Docket 52-002

May 18, 1994
LD-94-037

Subject: *ABB Combustion Engineering Topical Report CENPD-210, Revision 7A*

FIGURE II-2

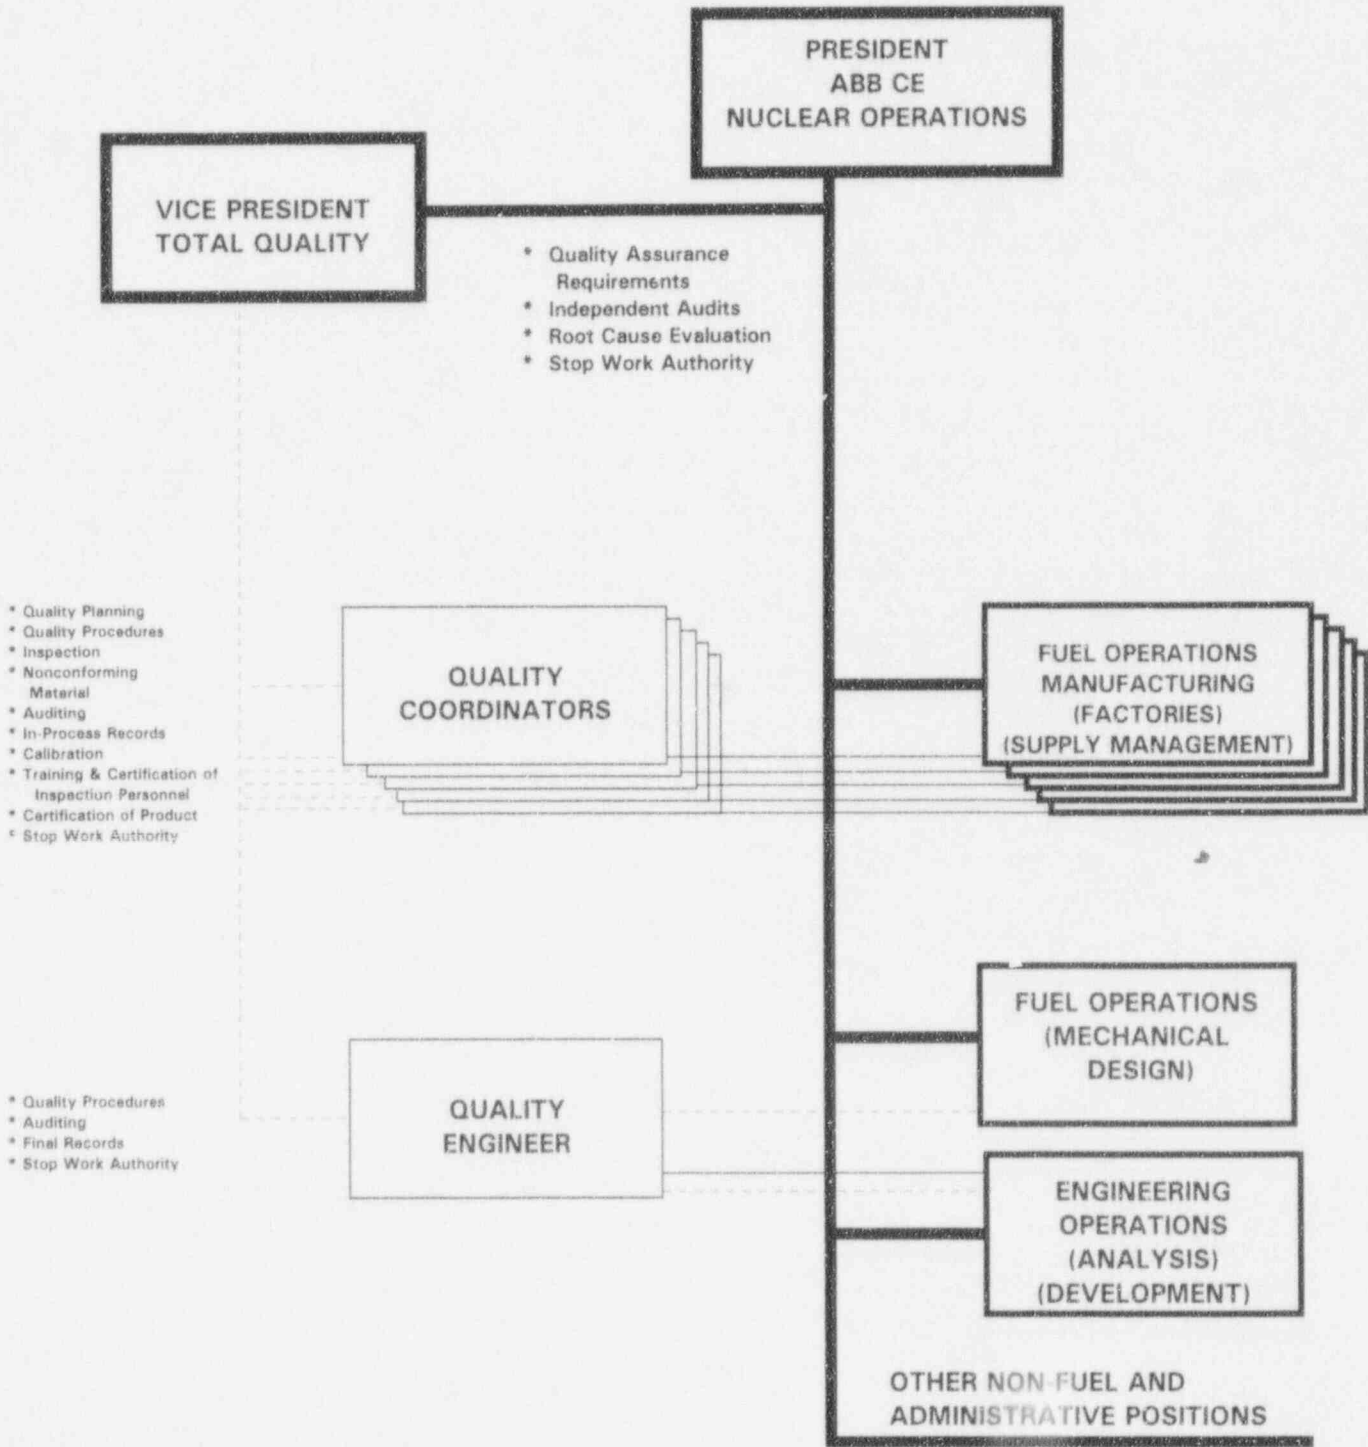
Figure II-2, attached, outlines the new organization and supersedes Figure II-2 of CENPD-210, Revision 7A, as modified in Letter LD-92-108. References to Nuclear Fuel (NF) in the text of the Topical Report shall mean Nuclear Operations.
